**BARTLOW ROAD S/1963/15/OL**

S/1963/15/OL Pembroke College, University of Cambridge & G.W. Balaam & Sons Ltd, land to north and south of, and immediate, Linton – residential development for up to 78 dwellings with landscape buffer and new vehicular accesses from Bartlow Road.

**Amendment 30<sup>th</sup> June 2016: Reduction in scale of development and revised site layout.**

**PC Decision: To NOT support**

## FLOODING

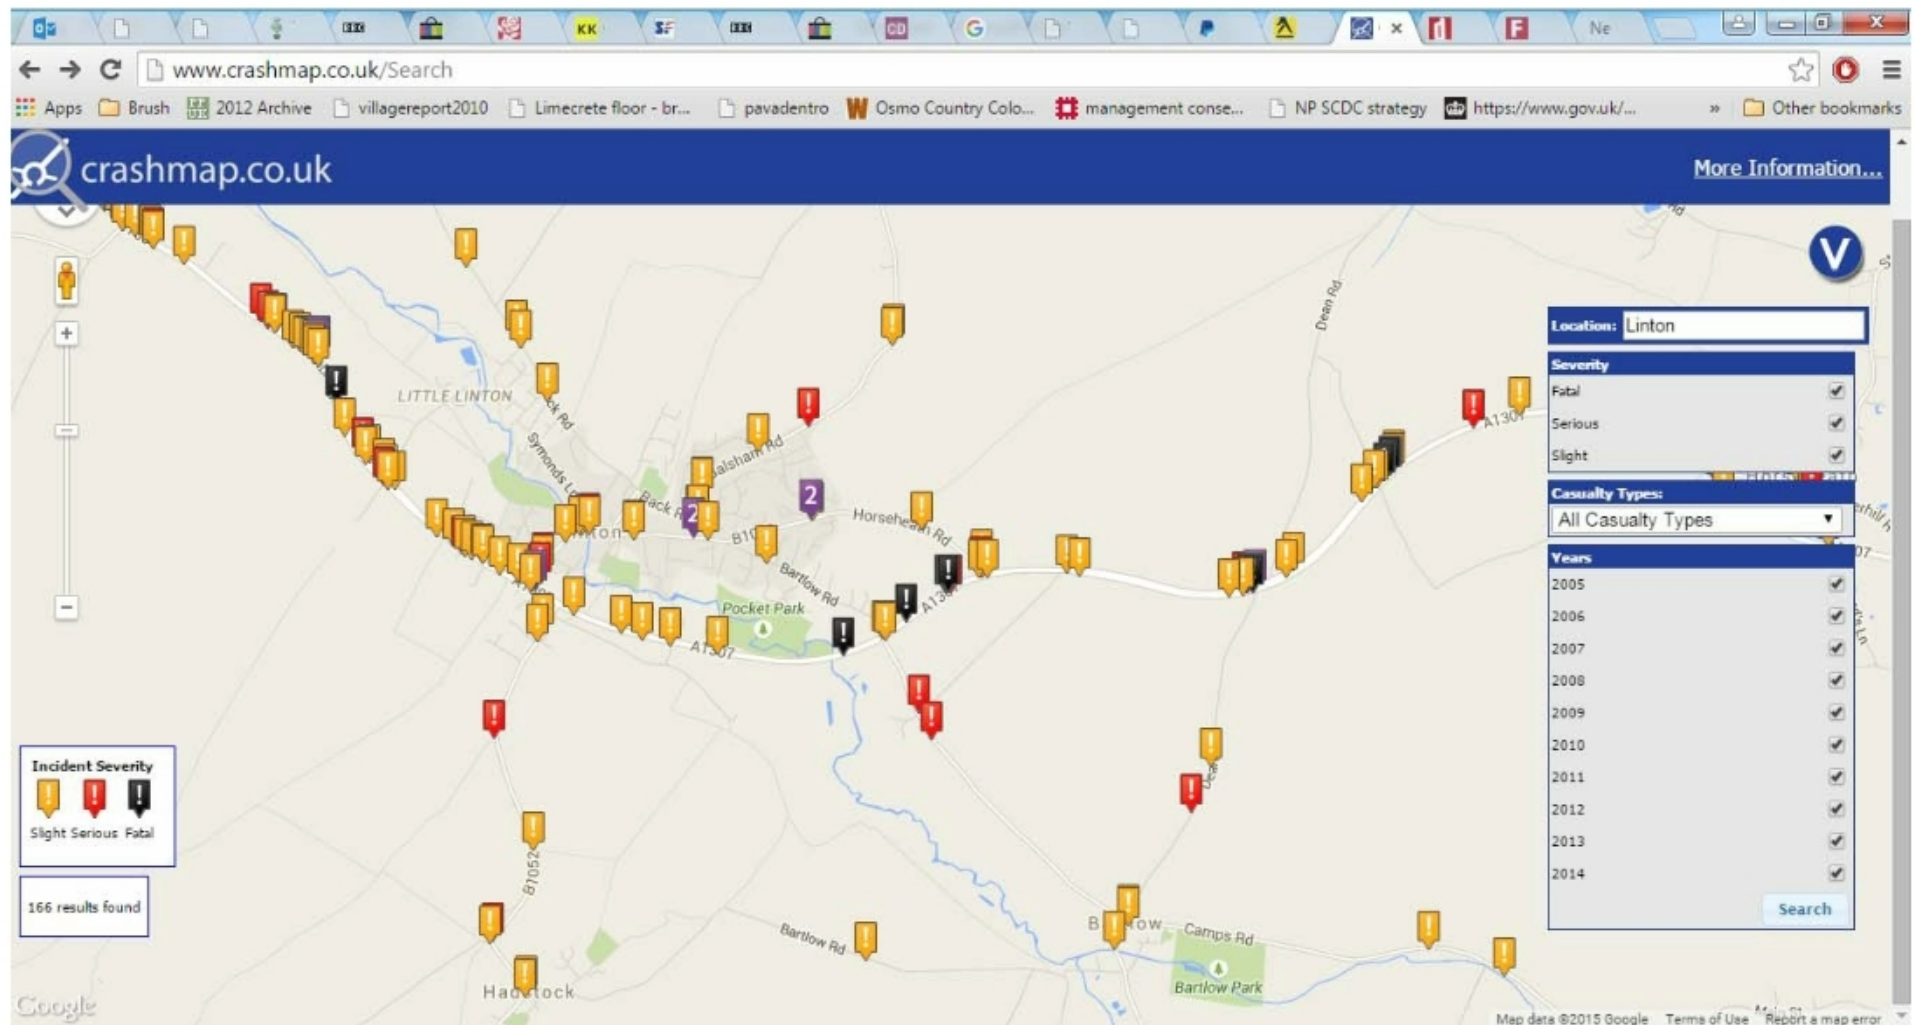
Linton is particularly sensitive to flooding and the records and photographs of flooding show that the risk is considerably greater than 1:100 event (see examples from two floods attached). As a result a number of affected villages along this part of the Granta / Cam have devised joint strategic approaches over the last few years in collaboration with the Environment Agency and South Cambridgeshire District Council. The land around Pocket Park and the eastern reaches of the Granta is critical to the success of the strategy, to flood the water meadows and fields upstream of the settlements to relieve flooding of the villages downstream. So far the strategy has proved successful as the houses in Linton did not flood during the most recent flood warning period. Linton Parish Council has invested substantially in the project and the recent works have changed the flood conditions significantly across the settlement and adjoining land. In future, it is expected that the fields to the east of the village (including the application site) may see greater flooding, and the village less.

The Flooding Assessment is out of date and should be revised to include:
